Attached are the revised site plan, screening plan and building drawings for the proposed pool and pool house at the McGarry's. There were four major adjustments made based on conversations with the Spring Point ARC:

Re: McGarry continued hearing information

MCGARRY POOL HOUSE

108 HAMMETT ROAD, CHILMARK MA

POOLHOUSE PLAN

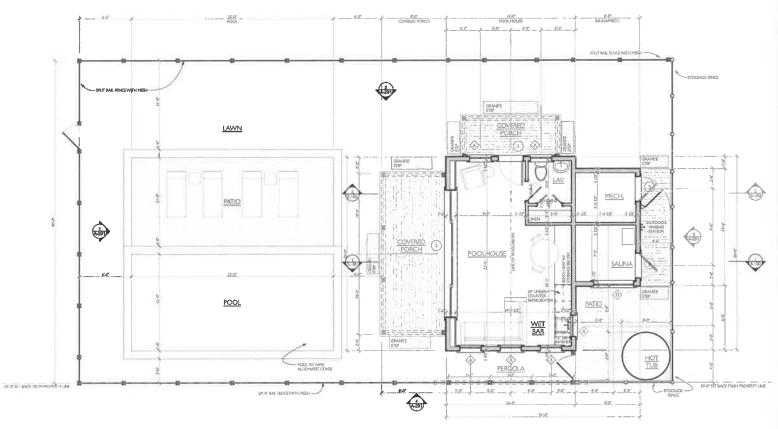
4. We've also indicated a few more cedar trees between the road and the fence.
As a result of the changes, the covered porch has been removed on the poolside of the pool house and the patio space has been relocated in that location.
Vineyard Land Surveying is planning on re-staking the new location this week so it should be ready for the site visit on June 23.
Please let me know if you need any full size copies sent out to you and if you need any other information.
Thank you very much.
Chuck Sullivan Principal Architect
sullivan + associates architects 52 narragansett avenue po box 989 oak bluffs, ma 02557 office 508.693.0500 x2 mobile 617.347.8600 sullivanassociatesarchitects.com
On Thu, Jun 10, 2021 at 9:54 AM Alison Kisselgof < akisselgof@chilmarkma.gov > wrote:
Hi Chuck-

1. The pool and pool house were moved 14' further away from the road, currently shown at 85' from the front

EXTERIOR ELEVATIONS

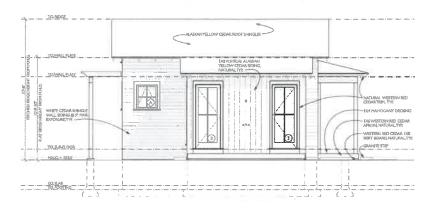
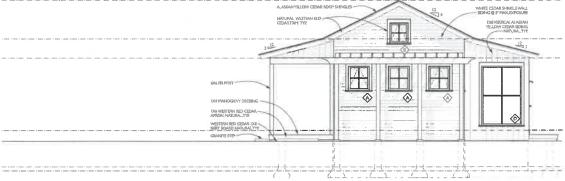
2. The pool house roof was lowered 18", now 16' at the highest point.
